# RECALL NOTICE

IC CORPORATION RECALL # 04305 NHTSA RECALL # 04V- 498 October 2004

# 30-Inch Child Restraint Seat Cushion Retention

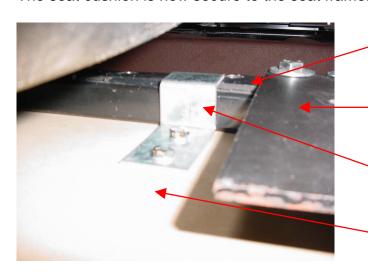
The 30-inch child restraint seat cushion retention may not retain the seat in all circumstances. In the event of a sudden stop, the seat cushion may tip forward and may become unattached causing the passenger to slide off the seat and/or be trapped by the seat cushion. This action could possibly result in personal injury or death.

Rectangular support is located in rear portion of seat cushion frame.

Reinforcement on aisle side of seat frame.

Z-shaped clip installed approximately 1-inch from reinforcement plate.

Under side of seat cushion.

- 1. Make sure that the cushion is in place and snug against the sidewall of the bus.
- 2. Using the metal Z-shaped clip, hold in place against the rectangular rear longitudinal bar and the board on the bottom side of the seat cushion. Leave about 1-inch between edge of clip and seat frame reinforcement plate.

- 3. Mark the locations of the fastener holes in the Z-shaped clip on the seat cushion board.
- Release the turnbuckle located on the wall side of the seat cushion.

- 5. Remove the seat cushion to drill holes and add clinch nuts.
- 6. Drill two 5/16 diameter holes at the locations marked in the prior step. You may want to use the Z-shaped clip as a guide for checking the location of the holes. When drilling these holes use caution not to penetrate beyond the thickness of the board, which is about 1/2 inch, to prevent damage to the seat cover.

- 7. Remove the staples that hold the seat cover to the board in the area where the holes were added to allow placing of the T-nuts.
- 8. Place one T-nut in each drilled hole from the cushion side of the board. They do not have to be pressed into the board. When the z-shaped clip is installed, the T-nuts will set themselves.

- 9. Replace the seat cover material and staple back in place.
- 10. The turnbuckle on the aisle side of the cushion must be turned with the handle side pointing to the aisle. This will provide clearance at the retaining end of the turnbuckle with the seat frame tube.

- 11. Return seat to the proper position, which requires the seat cushion to be tight against the wall of the bus.
- 12. Using two (2) ¼-inch bolts with ¼-inch lock washers, secure the z-shaped clip to the board using the T-nuts just installed. These bolts must be inserted into the nut insert that was just installed.
